EVALUATION OF PROPOSED CHANGES

License Amendment Request for Revision to the Wolf Creek Nuclear Operating Corporation Emergency Plan

FIGURE 3
TSC/OSC ORGANIZATION

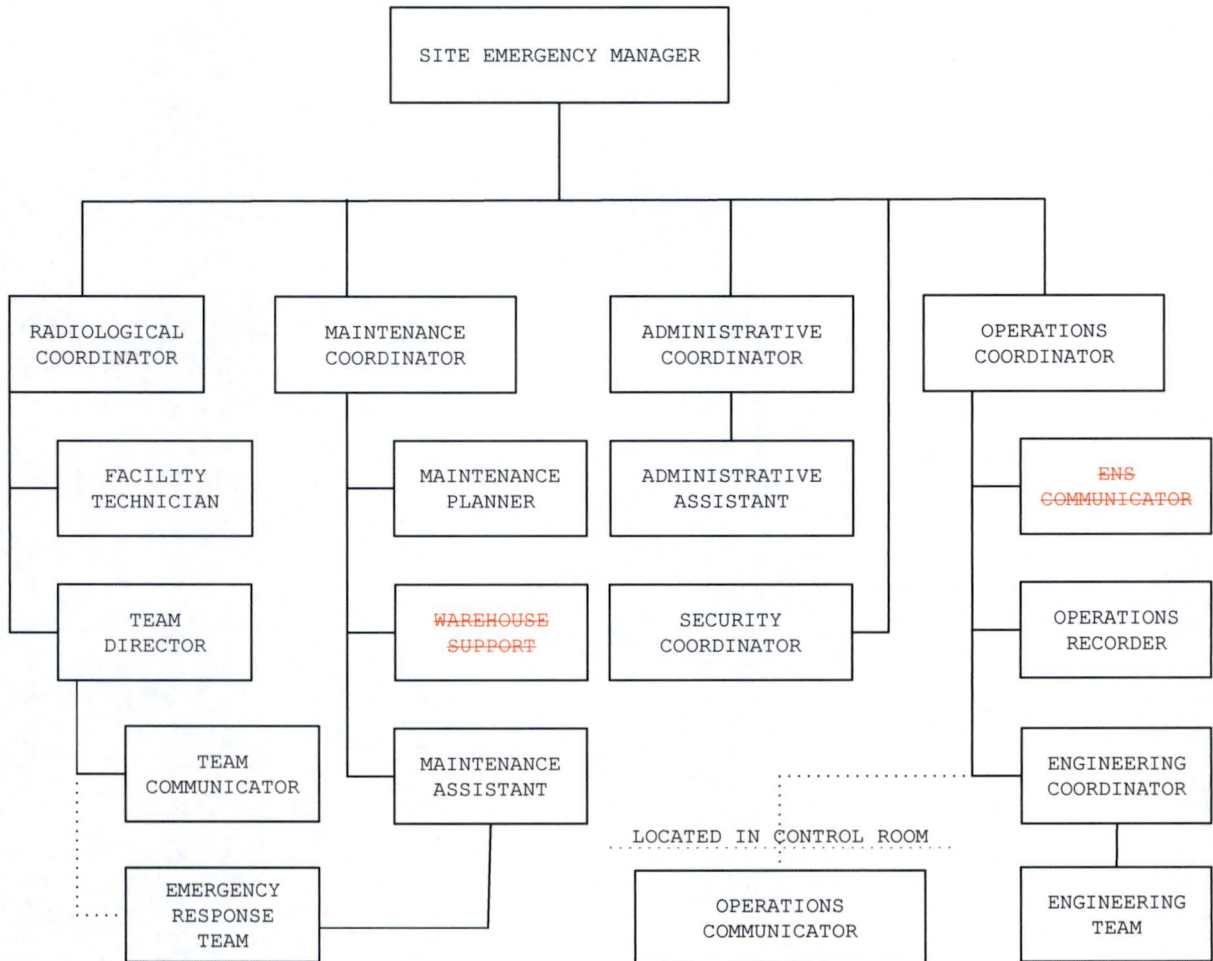
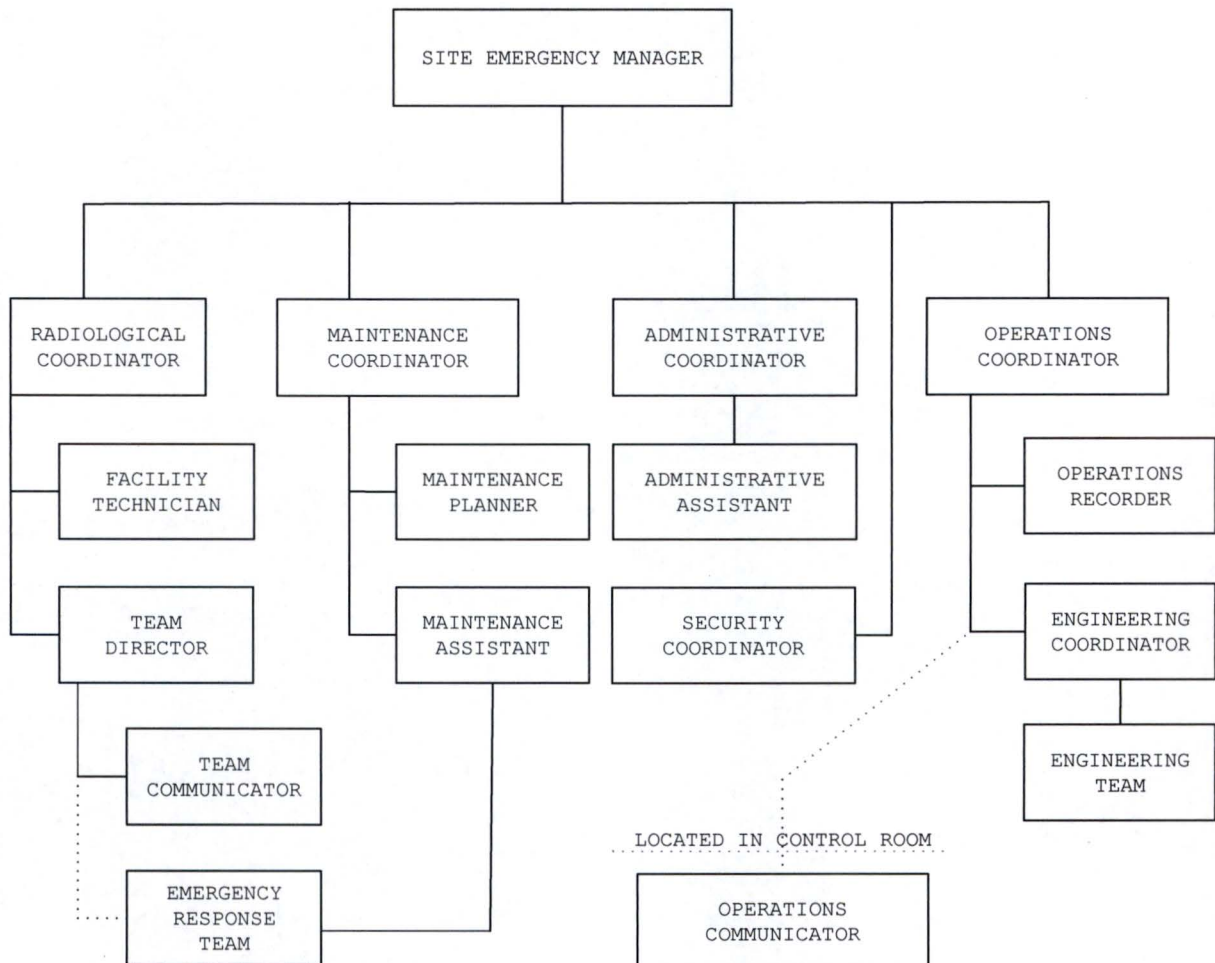
Figure 3, TSC/OSC Organization	ENS Communicator Warehouse Support	deleted	Reflect elimination of TSC ENS Communicator and Warehouse Support positions.

FIGURE 4
EOF ORGANIZATION

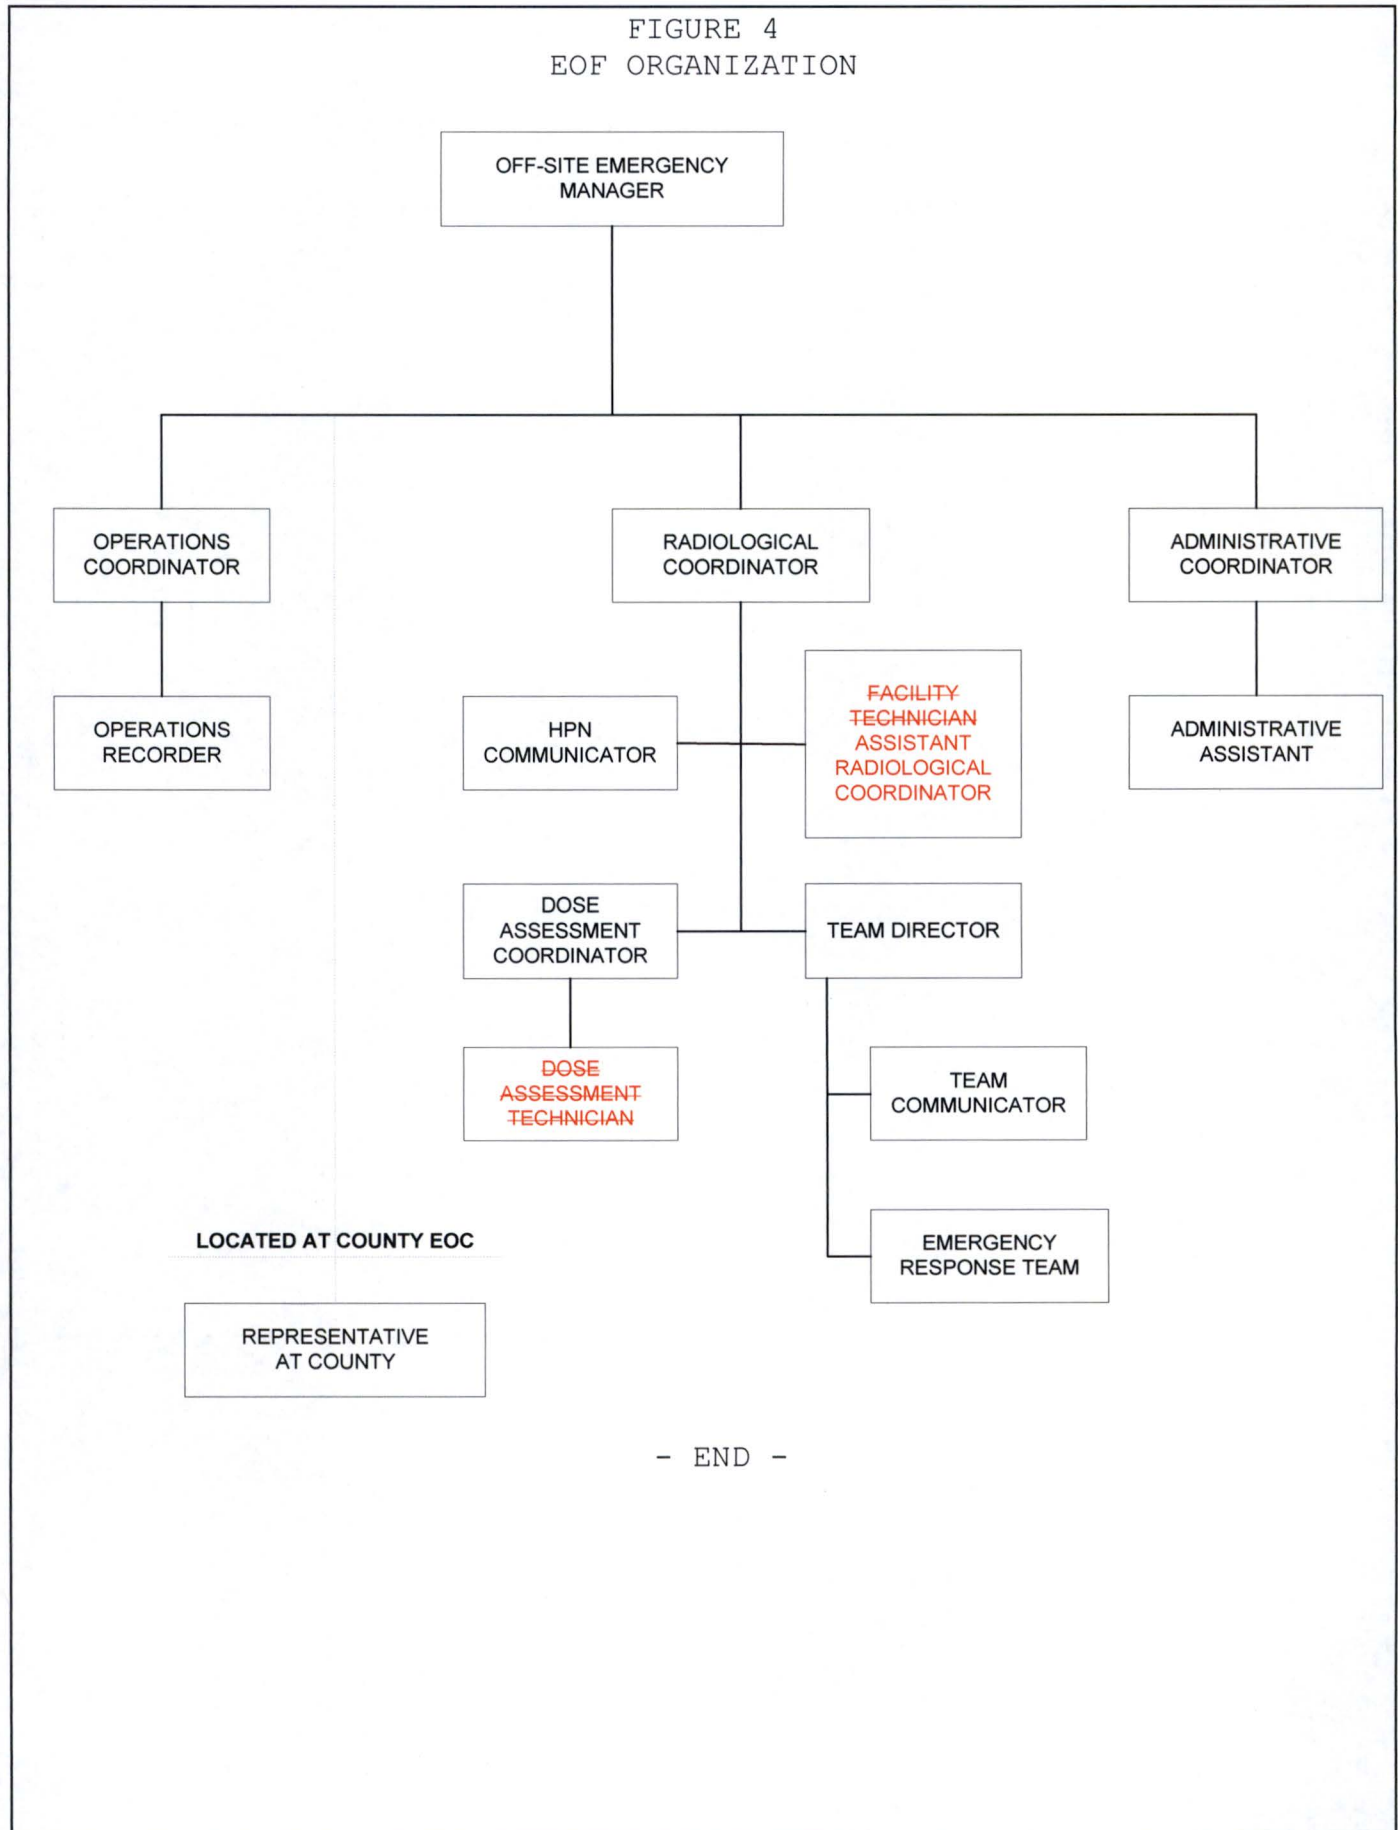
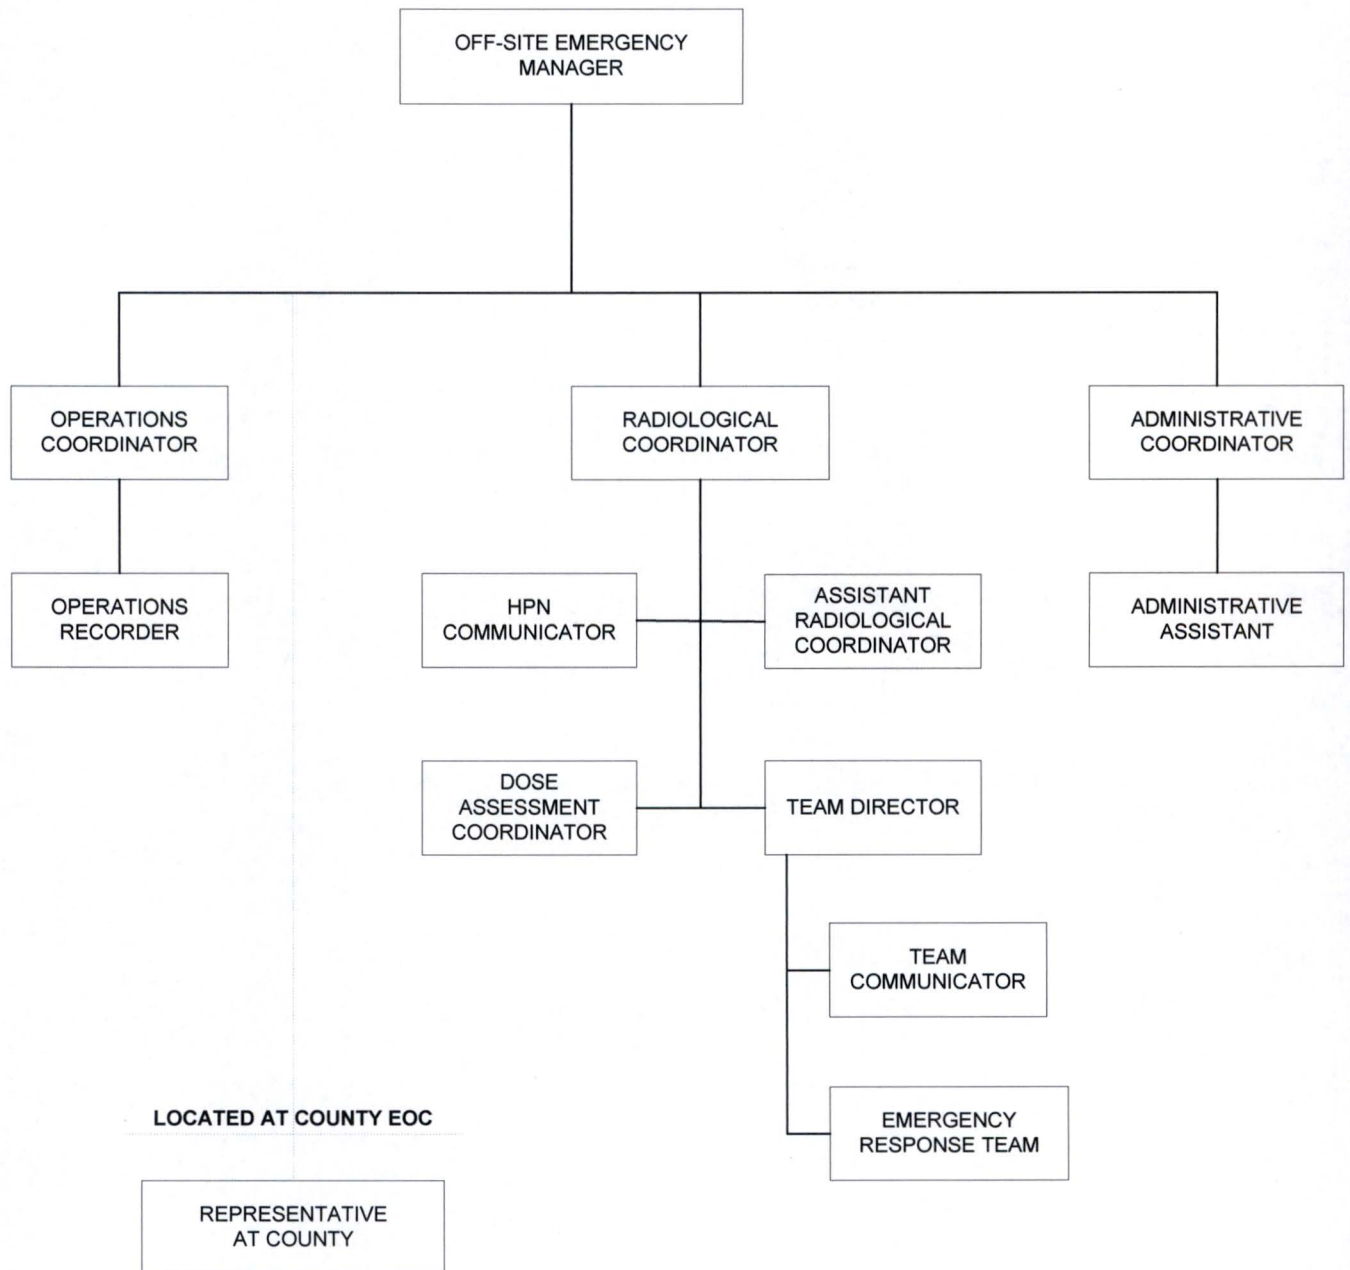
Emergency Plan Section	Before (Rev. 18A)	After (Pending Revision Number)	Reason for Change
Figure 4, EOF Organization	Facility Technician Dose Assessment Technician	Assistant Radiological Coordinator	Reflect elimination of EOF Facility Technician and Dose Assessment Technician positions. Reflect addition of an assistant to the EOF Radiological Coordinator position.
Figure 5, Public Information Organization	On-Site Public Information Coordinator (PIC) Media Liaison (MC)	deleted	Reflect elimination of On-Site PIC and Media Liaison positions.
